RE: 1817 Bluffside NW

Grading and Drainage Plan Engineer's Stamp Date: 10/21/19 Hydrology File: H11D015B

RE: 1817 Bluffside NW

Grading and Drainage Plan Engineer's Stamp Date: 08/17/19 Hydrology File: H11D015B

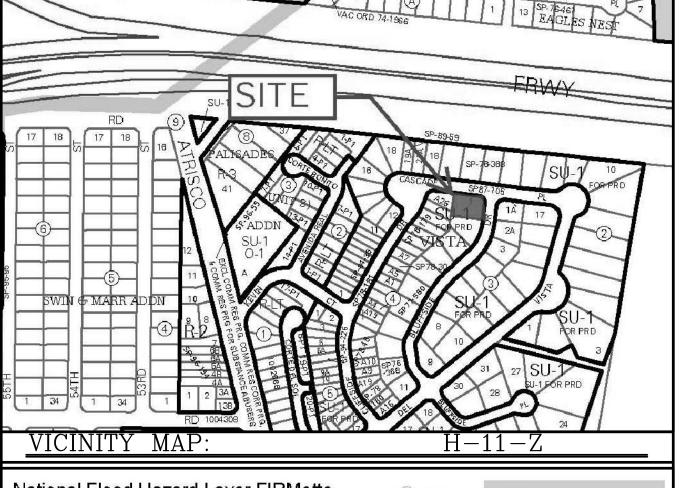
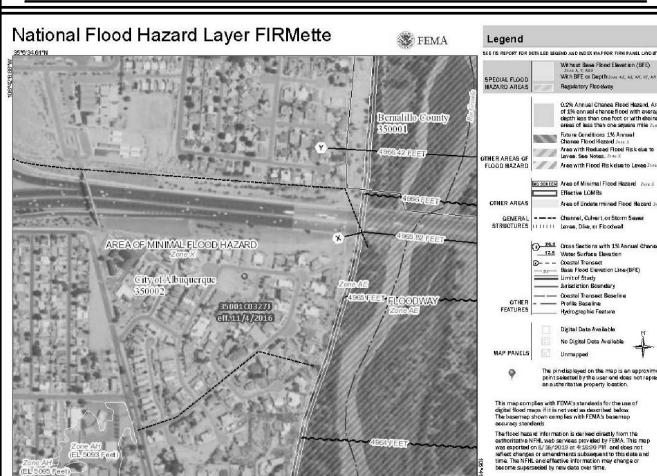
The topographic survey does not show the existing conditions along Casade Place correctly. As you can see in the July 24, 2019 photos show the vertical cuts that were not caused by drainage. This needs to reflect what the Owner's contractor graded within the public Right-of-Way along Casade Place N CONTOURS ARE COMPUTER GENERATED SPOTS ON CURB AND HOUSE APPEAR CORRECT

- 2. Provide the existing and proposed grades on both sides of the proposed retaining wall. we have added, proposed grades are extrapolated
- 3. Provide sections through all external boundaries showing proposed retaining walls, garden walls, property/ROW lines, existing and proposed grades. In accordance with DPM Ch.22, section 5 part B, grading and wall construction near the property line may not endanger adjacent property or constrain its use.

We have added sections and structural details by others
